KENWOOD

ASB-1053

Service Bulletin

Subject: TS-950SDX Change of Gate Resistor Type **Date:** March 28, 1994

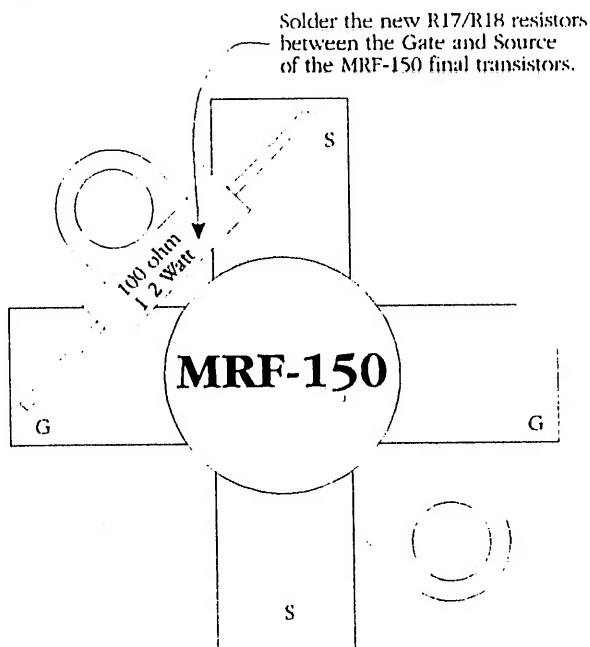
If the final amplifier is operated at excessive transmit levels (over 150 watts output) the final FET's may fail and short from Source to Gate. If this occurs, the bias resistors used in this circuit may be damaged and cause a large amount of smoke to be emitted from the final compartment.

Change the carbon type resistors used for R17 and R18 to the fuse type resistors specified below. This will prevent an unpleasant odor and smoke from the final compartment.

Qty	Description	New Part No.	Circuit Description
2	100 ohm 1/2 watt Fuse Resistors	R92-1310-05	R17, R18

Remove the old resistors from their locations on the circuit board and install the new resistors directly between the Gate and Source of the final transistors. (See the illustration below.)
